TALLAWONG STATION **PRECINCT SOUTH**

ADDENDUM URBAN DESIGN REPORT

Rev. F_20.01.2021

AMENDMENTS TO BUILDING ENVELOPES FOOTPRINT & STOREYS

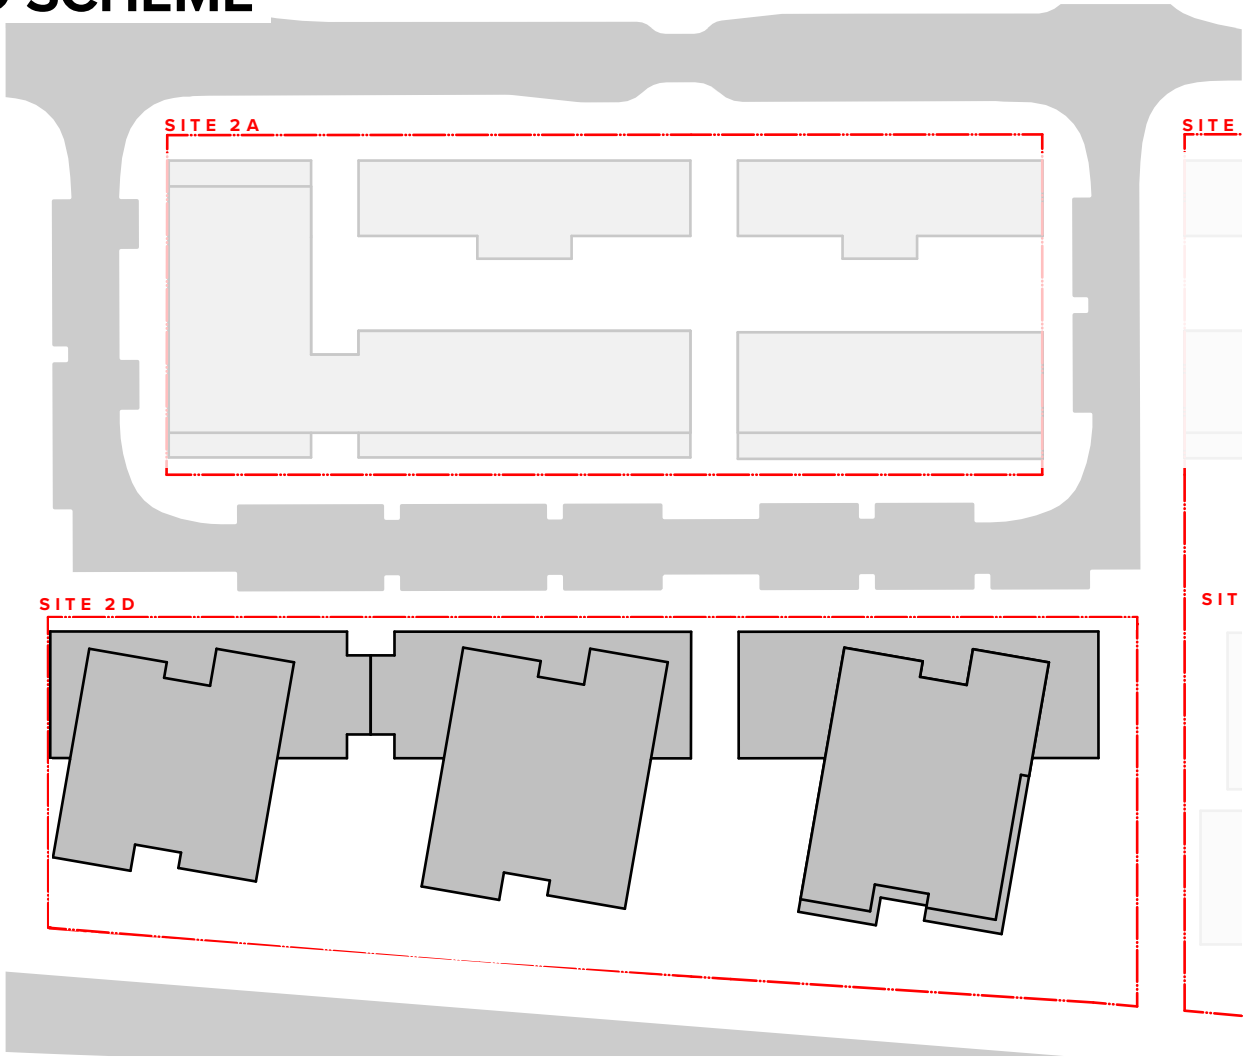
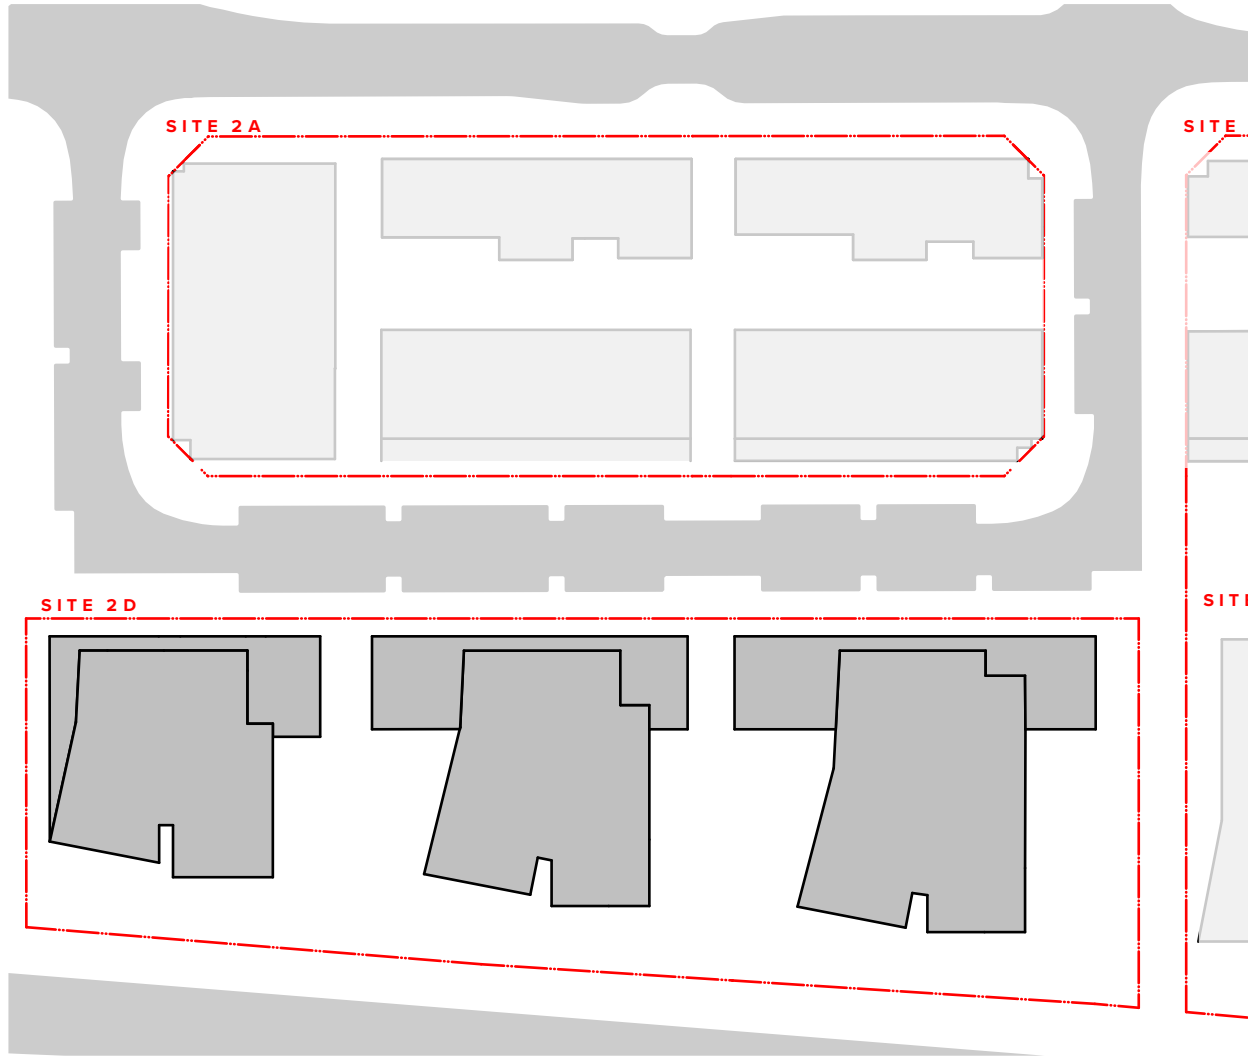
- ✓ Realign facade to orientate outlook north in response to solar access site building alignments
- ✓ Reduce upper building widths to the New Southern Road, increasing separation and outlook from the public domain
- ✓ Upper level setback to Schofields Road removed and balanced across new building form. Primary setback to Schofields Road maintained

SITE 1B BUILDING HEIGHTS

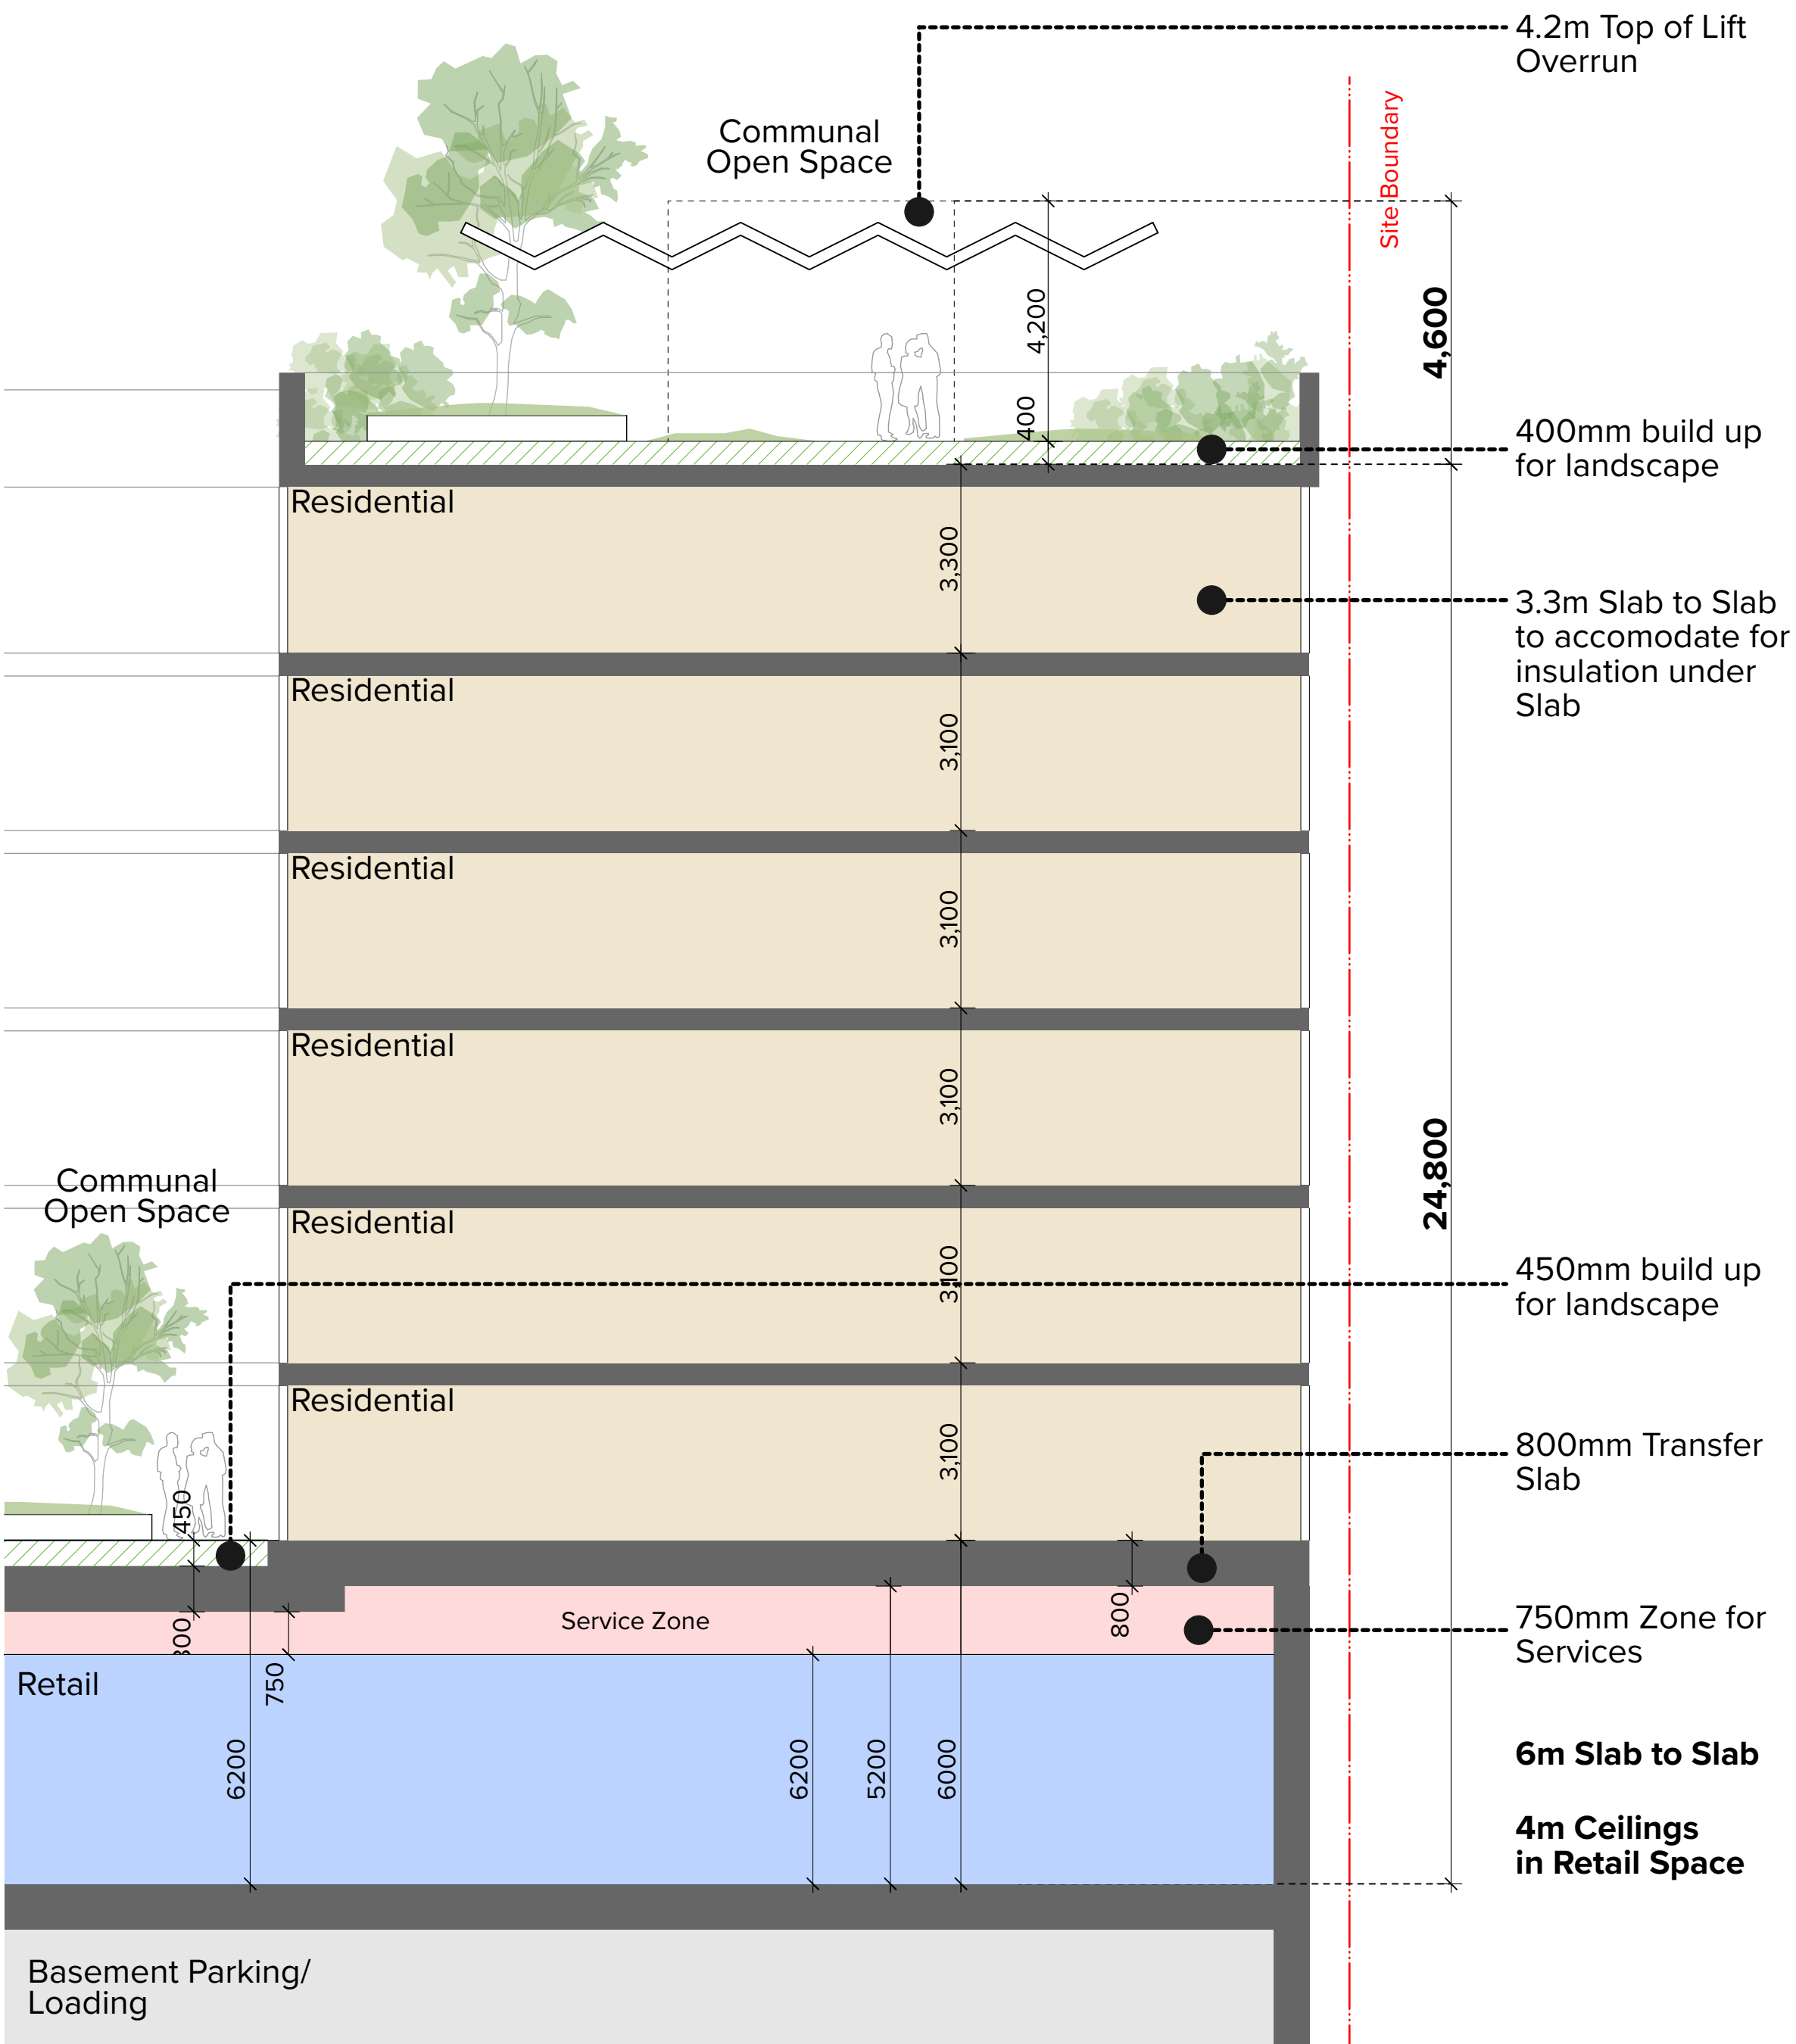
The approved SSDA scheme nominated a 4.0m ceiling height within a 4.4 metre floor to floor height. To accomodate adequate services zones and transfer depths, a floor to floor height of 6.0m is required to achieve a 4.0m ceiling height. This allows for a flexible retail provision that is adaptable to accommodate a number of alternate users over it's life.

Similarly the lift overrun has been assumed at 3.1m above the last level served as opposed to 4.2m which is the average requirement for most lift manufacturers.

These modifications to allow sufficient servicing, circulation and activation of the building marginally increases the heights of the buildings on the primary retail Site 1B.
